T.Y. LIN INTERNATIONAL
 THE STAMPED DOCUMENTS ARE HEREBY:
 APPROVED
 X APPROVED AS NOTED
 REVISE AND RESUBMIT
 SEE TRANSMITTAL FOR ADDITIONAL INFORMATION AS APPLICABLE.
 THIS REVIEW IS FOR GENERAL CONFORMANCE WITH DESIGN CONCEPT ONLY. ANY DEVIATION FROM THE PLANS OR SPECIFICATIONS NOT CLEARLY NOTED BY THE CONTRACTOR HAS NOT BEEN REVIEWED. REVIEW BY THE ENGINEER SHALL NOT RELIEVE THE CONTRACTOR OF THE CONTRACTUAL RESPONSIBILITY FOR ANY ERRORS OR DEVIATION FROM THE CONTRACT REQUIREMENTS.
 RICK HEBERT 2/2/2015
 DATE

NO.	DATE	REMARKS	BY
REVISIONS			
		CASCO BAY STEEL STRUCTURES ONE WALLACE AVENUE SOUTH PORTLAND, ME 04106 PHONE: 207-780-6722 FAX: 207-780-6726	
STRUCTURE		BENMONT AVE. (TH-7) (URBAN MINOR ARTERIAL)	
LOCATION		TOWN OF BENNINGTON, VERMONT	
PROJECT NO.		BRIDGE NO. 57 PROJECT NO. BRF 1000(16)	
ENGINEER		STATE OF VERMONT AGENCY OF TRANSPORTATION	
CUSTOMER		ALPINE CONSTRUCTION	
ITEM		CALC PLAN	
SURFACE PREP.		OPEN HOLES	
PAINT			
APPROVAL	DRAWN WCG	12-2-14	SHEET NO.
SHOP	CHECKED LX	12-5-14	WS1
			JOB NO. 605

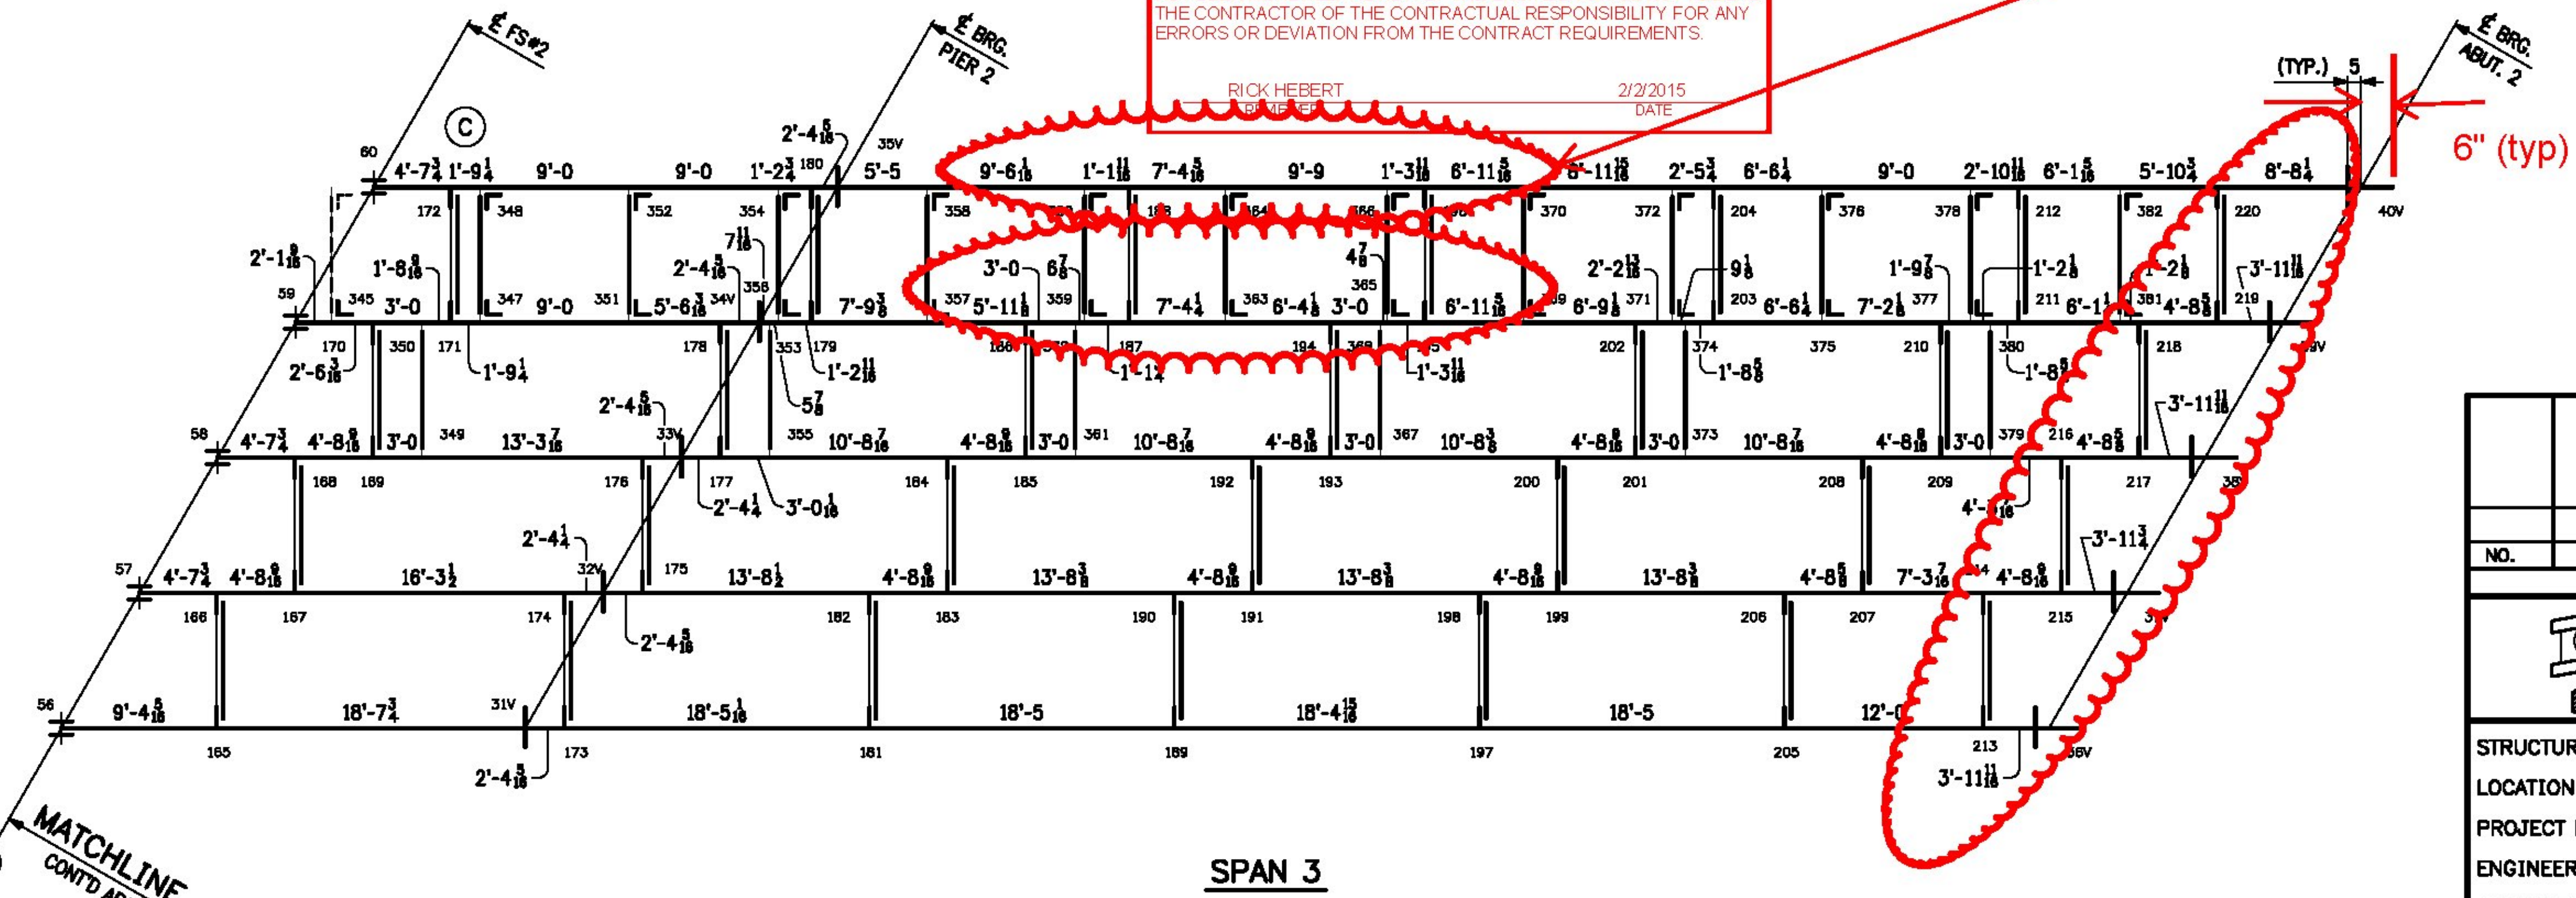
To clarify, Dimensions are OK to CL Bearing and not to bearing stiffener (typ)

Spacing of waterline support beams are not all at 9'-0" spaces as shown on Contract Drawing Sheet 39 of 75. Maximum variation appears to be 9". The increase in span is acceptable, however the Contractor should refer to the Special Provision (Water Main on Bridge) to ensure compliance with the hanger distance to pipe joint requirements are also met.
